Responses to Comments from Anonymous Referee #1

Figure 2

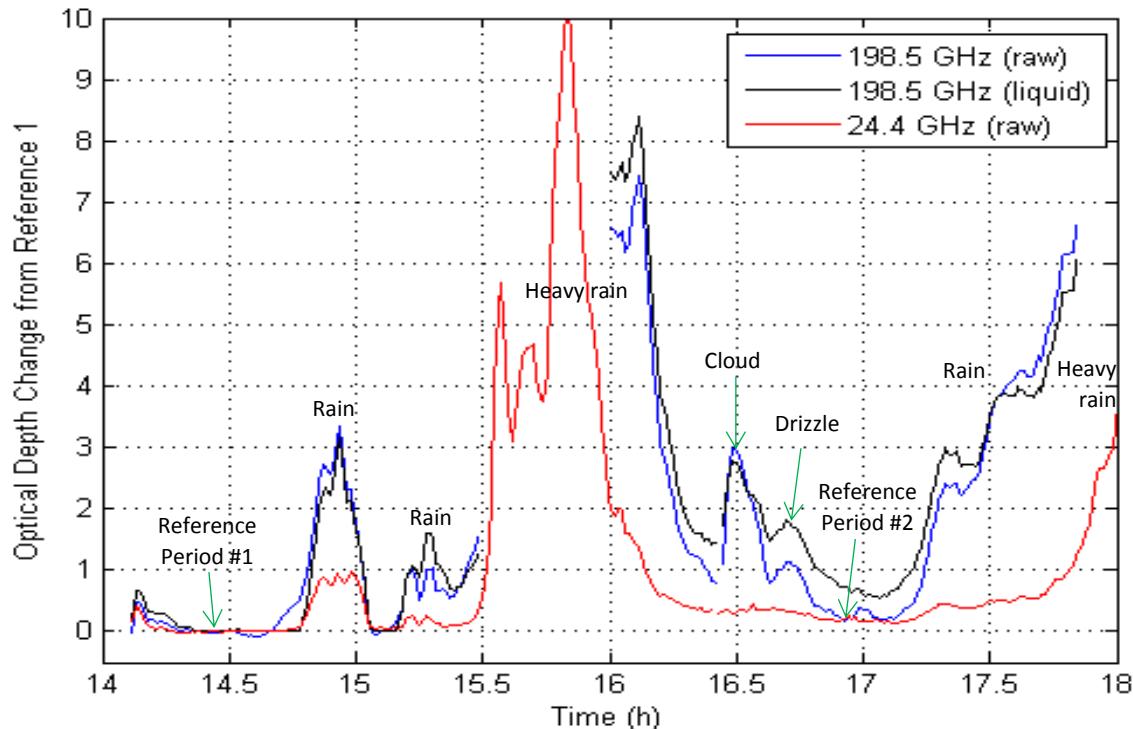
3. It looks like the wrong figure was uploaded as it is missing the annotations. Below is the figure 2 that should have been included with the paper. Figure 2 in the original document has been changed to the figure below.

13. Replacing figure 2 eliminates this issue.

17. Taken care of with the correctly annotated Figure 2.

25. Figure 2 will be replaced with the annotated figure.

Figure 2. Blue and red lines show observed changes in optical depth at 198.5 GHz and 24.4 GHz relative to reference period 1. The black line shows changes in optical depth at 198.5 GHz due to changes in liquid water after removing the contribution from changes in vapor pressure and temperature.
